SUNDRY NOTICES AND REPORTS ON WELLS
Do not use this form for proposals to drill or to re-enter an abandoned well. Use Form 3160-3 (APD) for such proposals.5. Lease Serial No.
100-25494

☐ Oil Well ☒ Gas Well ☐ Other2. Name of Operator
B C Operating, Inc.3a. Address
P O Box 50820
Midland, TX 797103b. Phone No. (include area code)
(432) 684-96967. If Unit of CA/Agreement, Name and/or No.
355048. Well Name and No
Shell Federal #29. API Well No.
30-015-346794. Location of Well (Footage, Sec., T., R., M., or Survey Description)
1980' FNL & 660' FWL
Sec 6, T21S-R24E10. Field and Pool or Exploratory Area
Cemetart (Morrow)11. Country or Parish, State
Eddy County, NM

Plug and Abandon well as follows:

Wellbore Diagram

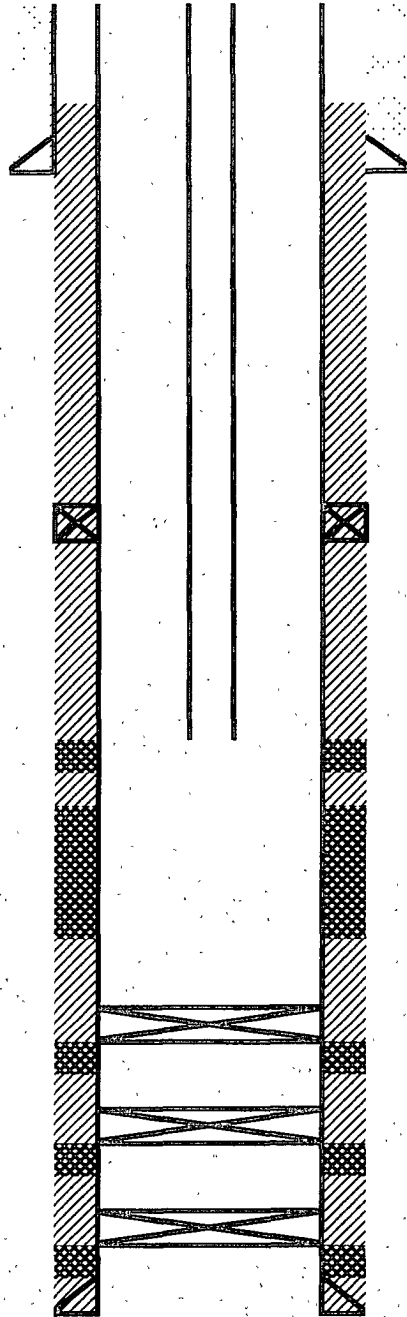
* add shoe plug (25 sx min) from 1433 - 1333. WOC Tag
* Perf @ 60' circ in/out of 5 1/2"
